Access Compliance Report

Public Rights-of-Way

(Curb Ramps)

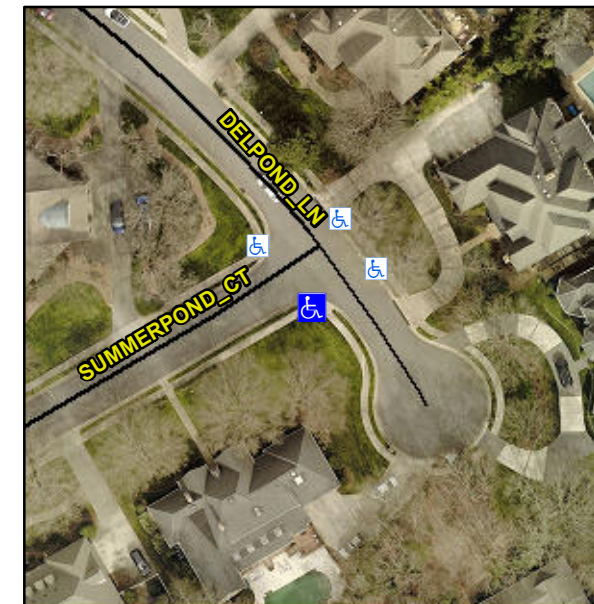
Surveyor Notes:

LT RP < 5%

PROW/ADA:

R304.5.1, R304.5.3, R304.3.2

Possible Solutions:

Remove & Replace Curb Ramp With Two New Directional Ramps or Equivalent.
